**NORTH
LINCOLNSHIRE
GREEN
ENERGY PARK**

9.8 Applicant's Response to Written
Questions

PINS reference: EN010116

December 2022

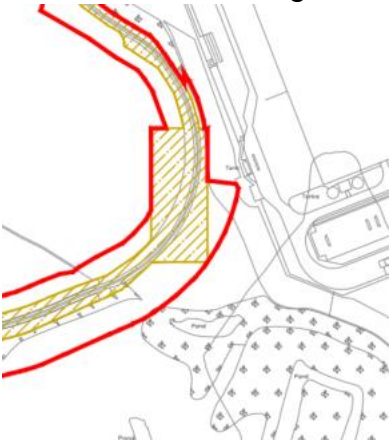
Q7.1.32	The Applicant	<p>Work No.3</p> <p>This work makes no reference to a footbridge or bridges. Should this be specifically added?</p>	<p>A proposed footbridge is shown on Work Plan C3 as indicated below. The second footbridge is also on Work Plan C3 and works are all within the yellow hatched area but it isn't clearly indicated and so updated indicative railway drawings will be produced to show location and parameters. The Applicant has also added reference to footbridges in Work No 3 in the updated dDCO.</p> 
Q7.1.33	The Applicant	<p>Work No.3 and Work No. 4</p> <p>There do not appear to be any laydown areas within either of these work areas, is this correct?</p>	<p>A laydown area is shown on Works Plan C5 (APP- 018) within the Dragonby Sidings.</p> <p>Laydown areas within Works Plans A (particularly A16 – APP-016) may also be used for this purpose.</p>
Q7.1.34	The Applicant	<p>Work No. 4</p> <p>(i) Can the Applicant confirm what the “associated equipment to allow loading and unloading” at the proposed railhead (Work No. 4 of the dDCO [APP-007]) would comprise and their anticipated dimensions?</p> <p>(ii) Are any buildings required?</p>	<p>(i) Refer to APP-045 para 3.3.12 which states that “reachstacker” mobile container handling machines would be used, each approximately 11.2m in length, 6m in width and 4.8m in height when at rest.</p> <p>(ii) No buildings would be required.</p>

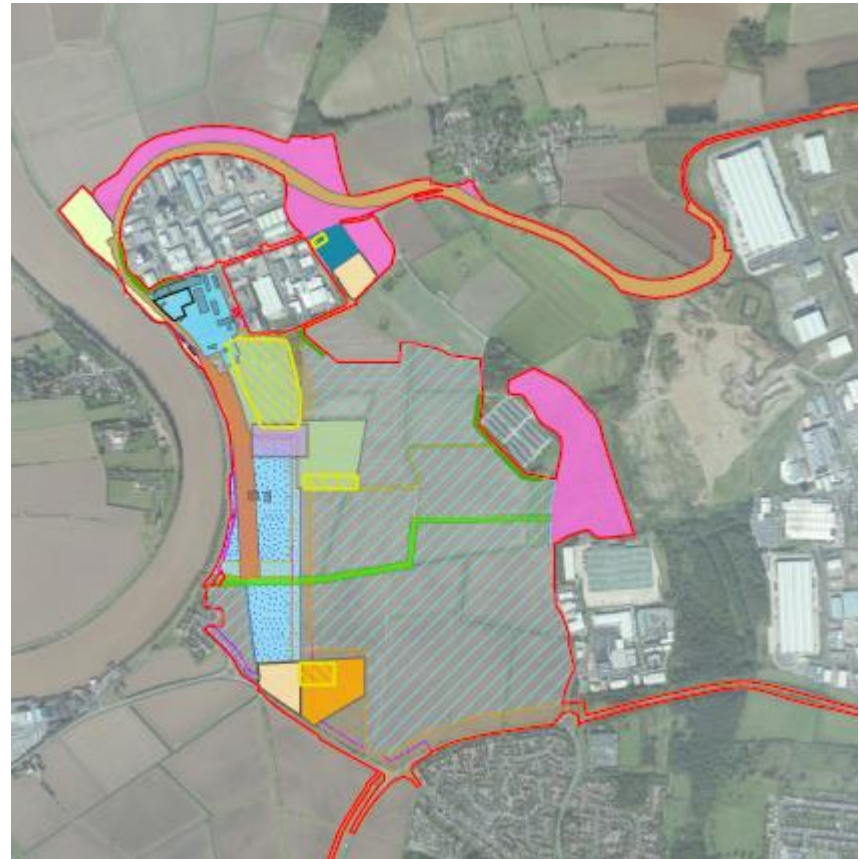
Q9.0.13	The Applicant (i and iii), NLC and Historic England (ii and iii)	<p>Historic Landscape Character Assessment (HLCA)</p> <p>(i) Within the ES [APP-060] paragraphs 8.4.1.2 and 8.4.1.3 the Applicant states ‘If the HLCA is considered to be of moderate</p>	<p>(i) No, the banding of importance of assets within ES Chapter 12: Archaeology and Cultural Heritage (APP-060) acknowledges that HLCA’s can have differing levels of importance depending on individual circumstances. Please refer to Table 4 in this document, which notes that “well preserved historic landscape character areas, exhibiting considerable coherence, time-depth or other</p>

<p>value'. Is it correct to assume the value you attribute to each HLCA as moderate?</p> <p>(ii) Do the Council and Historic England agree that the Axholme Fens and Normanby Scarp HLCA has moderate value??</p> <p>(iii) What weight should this assessment have within the planning balance?</p>	<p>critical factor(s)” can be considered high value for example. And, conversely, that “historic landscape character areas whose value is limited by poor preservation and/or poor survival of contextual associations” can be considered of low value.</p> <p>(ii) This question is not for the Applicant.</p> <p>(iii) Noting the requirements of NPS EN-1 paragraph 5.8.15 it is important to weigh any harmful impact on the significance of a designated heritage asset against the public benefits of the development, recognising that the greater the harm to the significance of the heritage asset the greater the justification will be needed for any loss. Whilst both heritage assets are considered of moderate value, the ES [APP-060] only identifies significant effects at Axholme Fens HLCA. In line with NPS EN-1 Paragraph 5.8.14 and Paragraph 202 of the NPPF, this effect is considered to constitute less than substantial harm.</p> <p>The weight of this assessment should be proportionate to the level of harm to the significance. The Applicant would therefore suggest that less than substantial harm to a heritage asset of moderate value should be given limited to moderate weight in the planning balance. In the Applicant ‘s view, when applying the planning balance, it is considered that the significant public benefits of the Project outweigh the significant effects identified to the Axholme Fens HLCA during the stages of the Project’s limited lifetime.</p> <p>It should be noted that the ExA’s report for the Keadby 3 DCO, which was made on 7th December 2022 and is located on the other side of the River Trent from the</p>
